JACKSON STREET SIDEWALK IMPROVEMENTS – PERRYMAN TO MILLER

Addendum No. 01

ADDENDUM 01

INTERSECTION
& DRIVEWAY
DETAILS

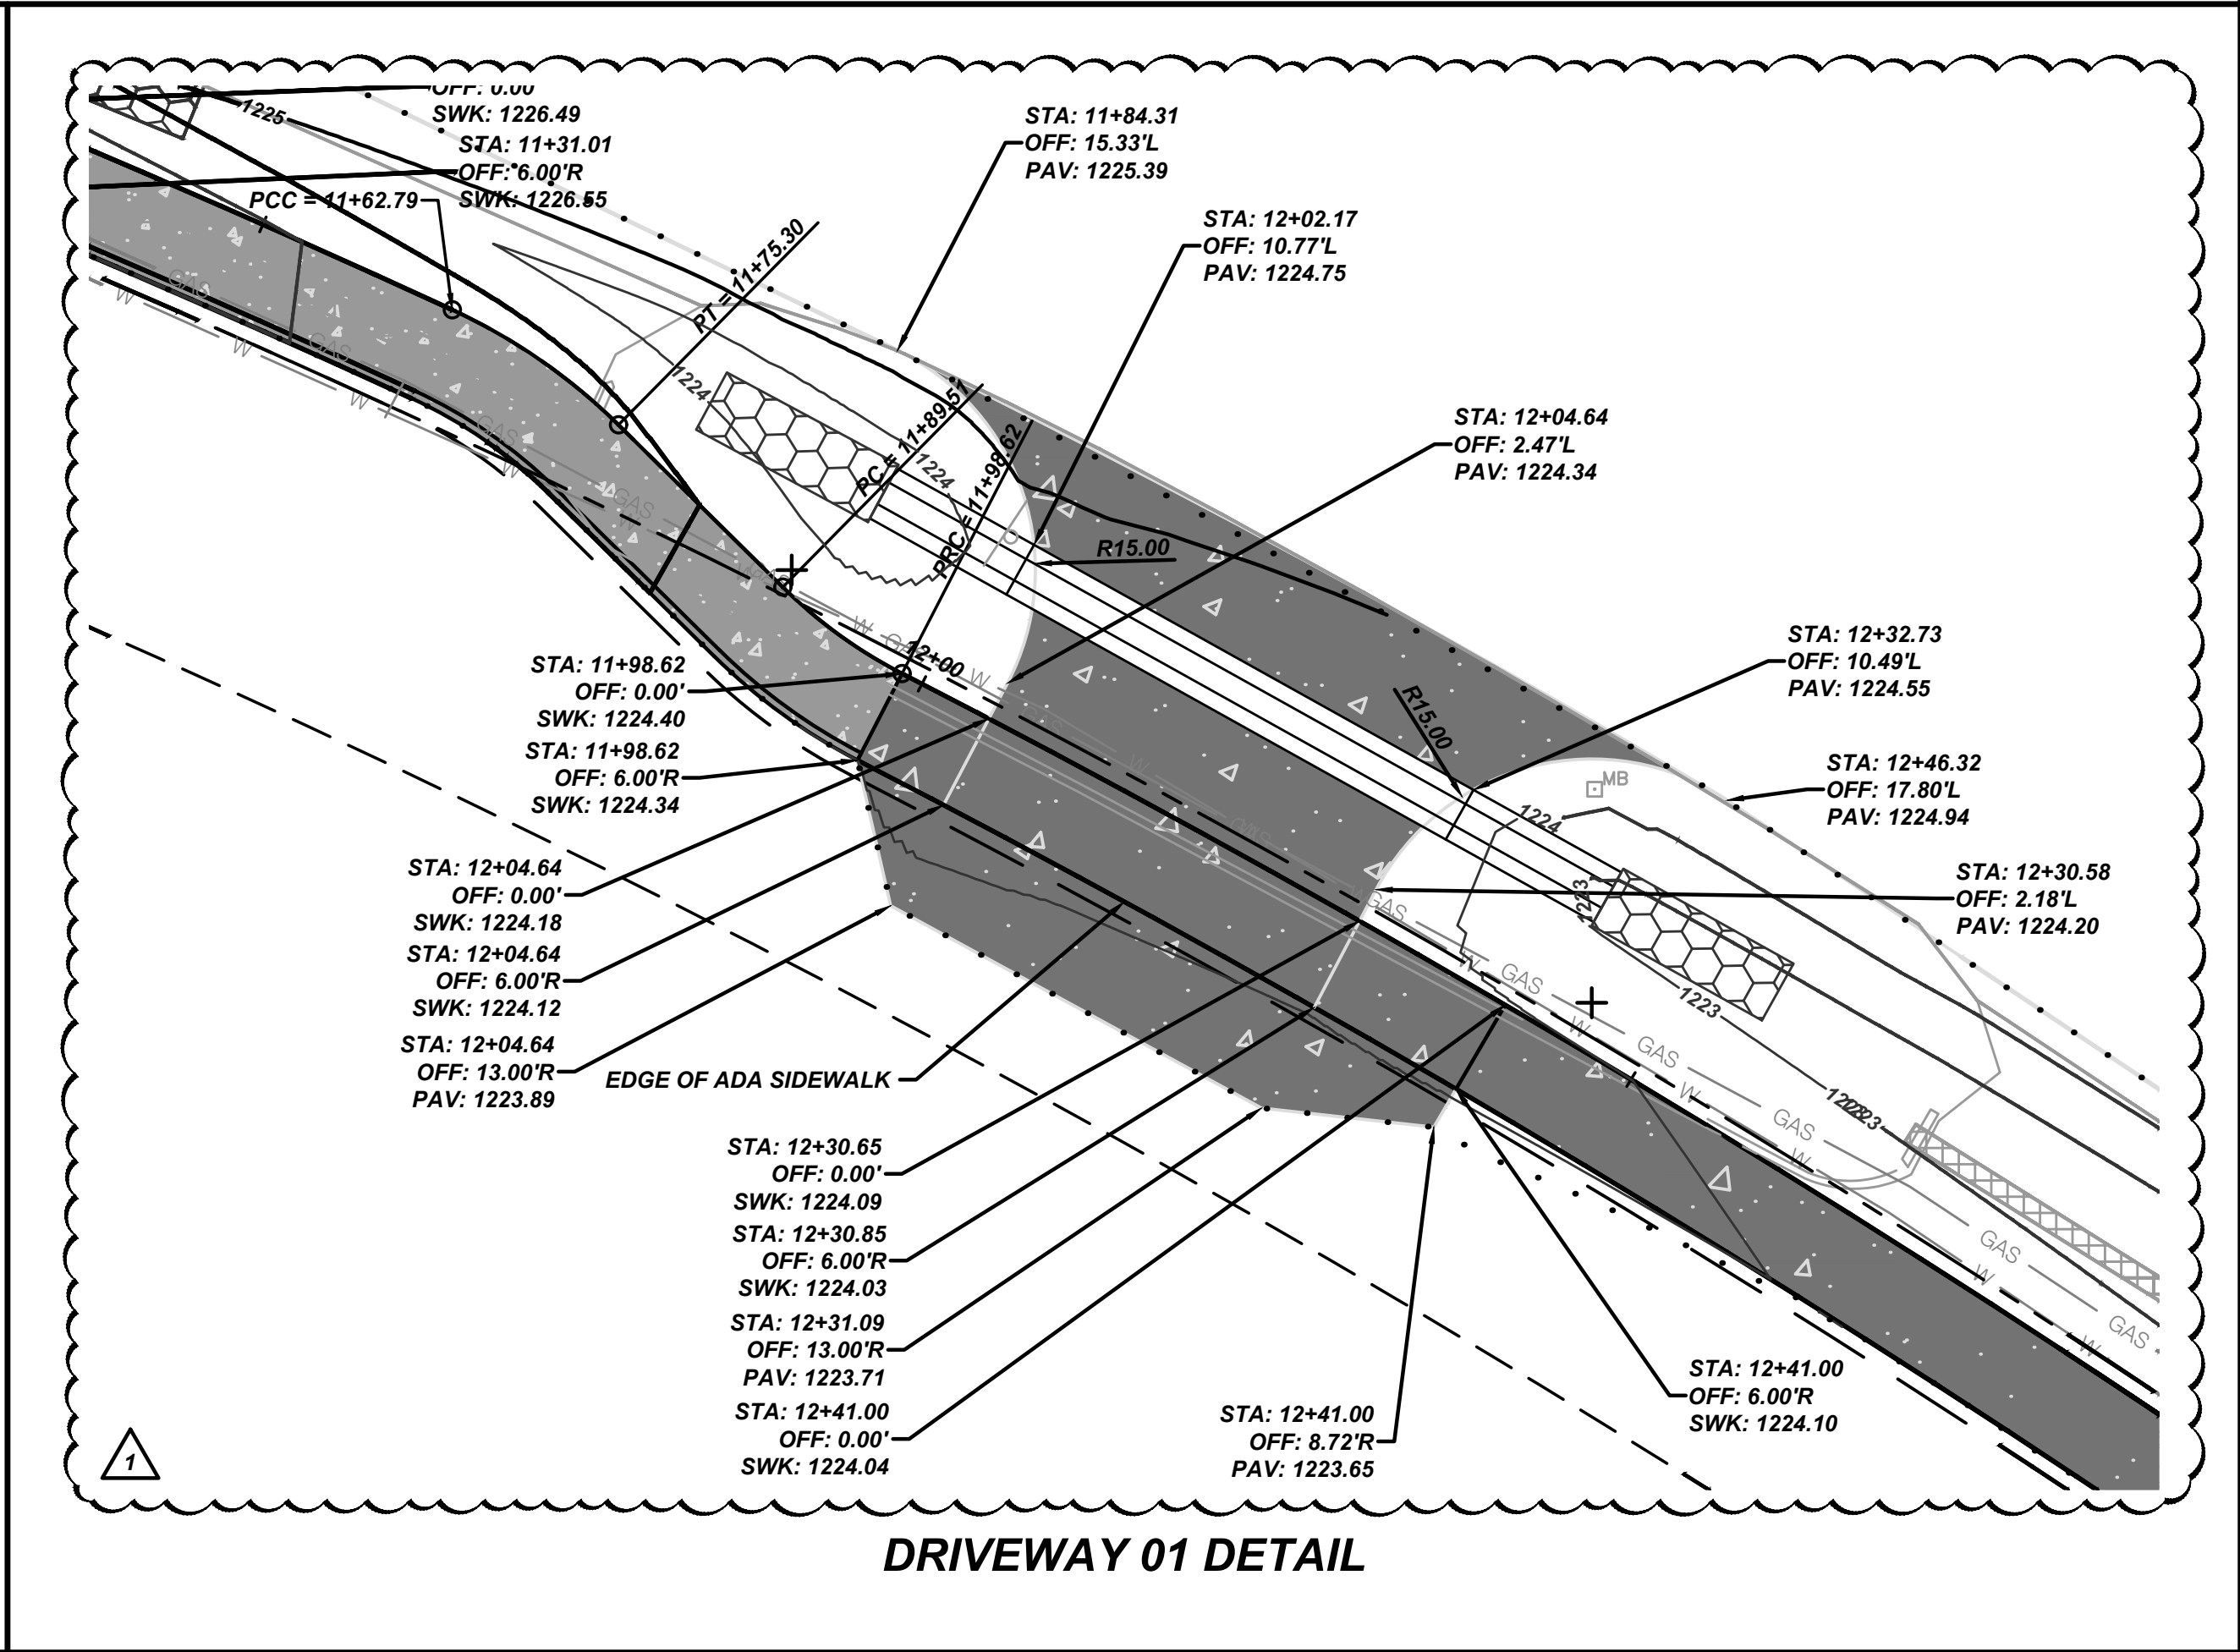
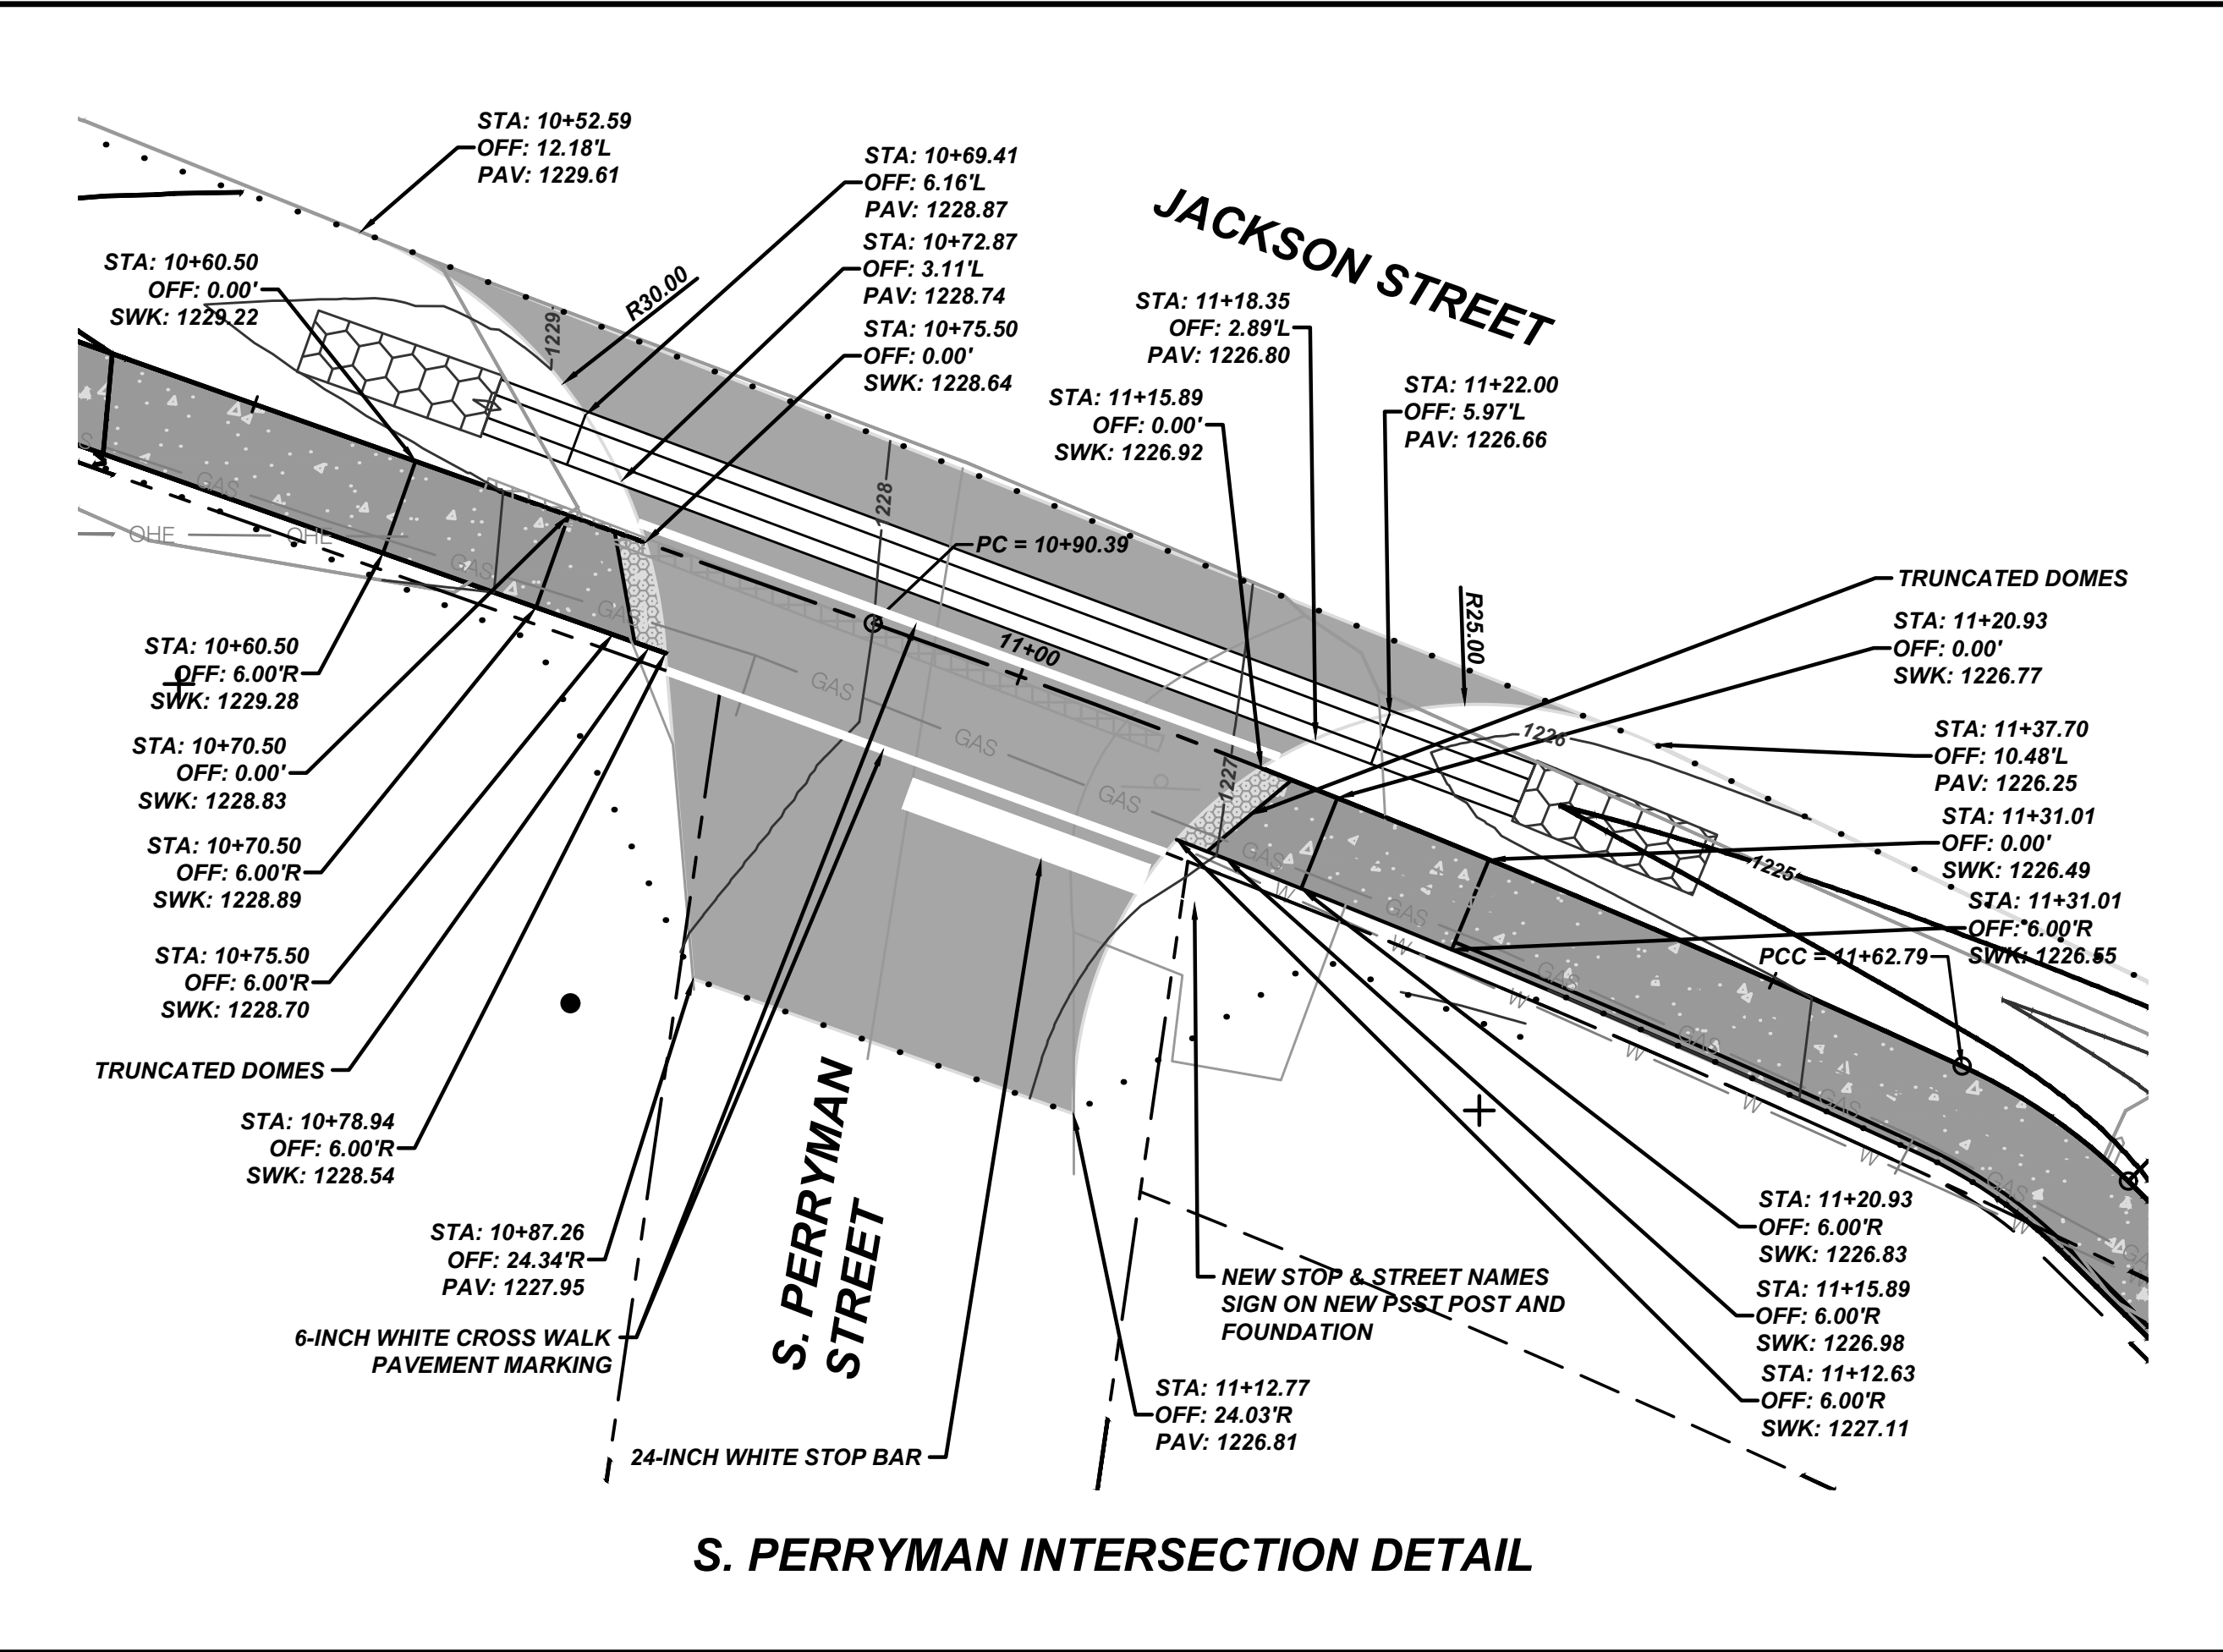
SHEET 09: The Plans have been revised to show the revised grading of Driveway 01.
